#### APPLICATION FOR A CERTIFICATE OF APPROPRIATENESS – STAFF REPORT

088-17-CA 227 ELM STREET

Nature of Project: Installation of 8' x 16' freeform concrete spa with stone surround

Picture of Backyord
Where Spa ii
Being install-1

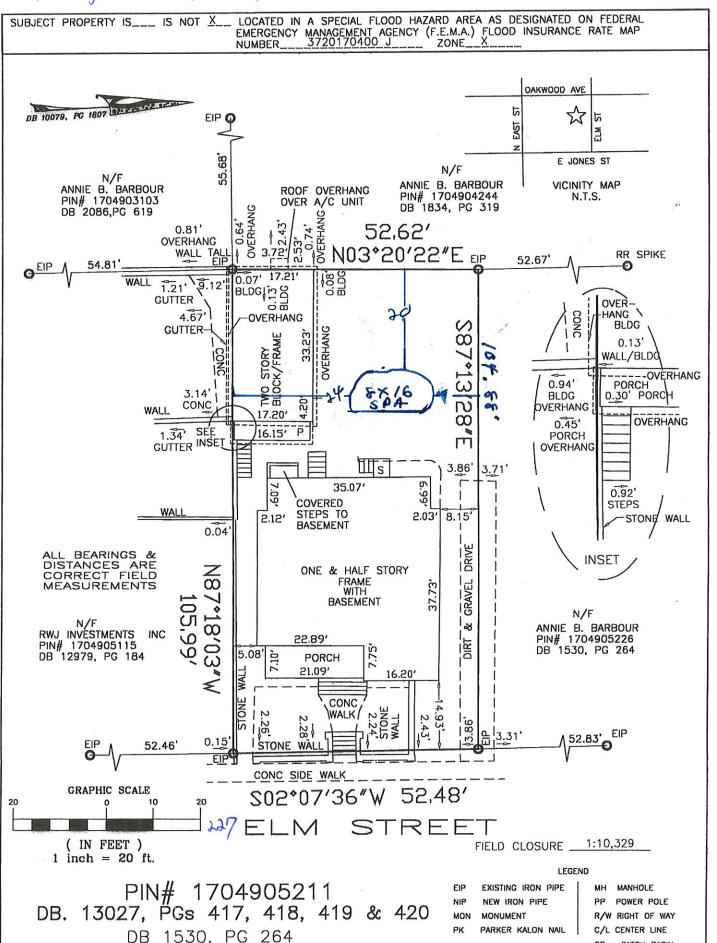
$\sqrt{1}$ . Please confirm the dimensions. The application shows it being 8' x 14', but the sketch on the plat shows 8' x 16'.

Pool/spa 8 ×16 or smalle, 3/6" To 5/6" Deep

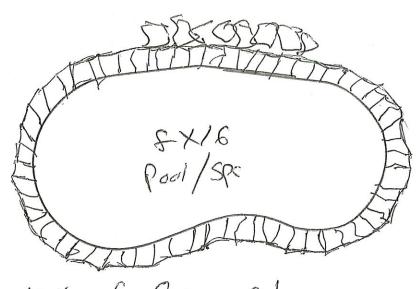
3. Please provide more detailed drawings showing how it is designed. The drawings should show dimensions of the spa and the stone surround and should be drawn to scale. It might help to have a section view (a view that is essentially a vertical slice through the spa) so that the COA Committee members can see how deep it will be and how thick the stone surround will be.

1611 of Copins Store Store natural Bouldes on Back

### Color of stop capins

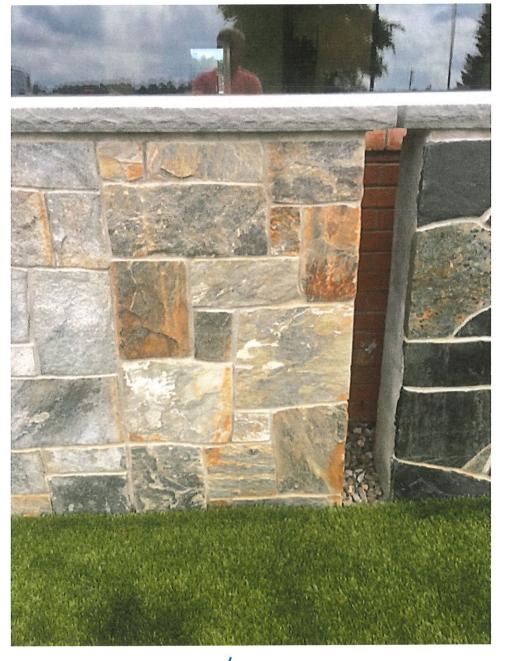
- 4\* The pool will be edged with 16" wide coping stone, with a grouping of natural boulders on the back side. The proposed stone is similar in color to the stone retaining wall along the front sidewalk.
- $5^*$  The property at 225 Elm Street, immediately to the south of the applicant's property, was granted a COA (073-13-CA) four years ago for a similar spa/pool installation in the backyard, measuring  $7' \times 11'$ .
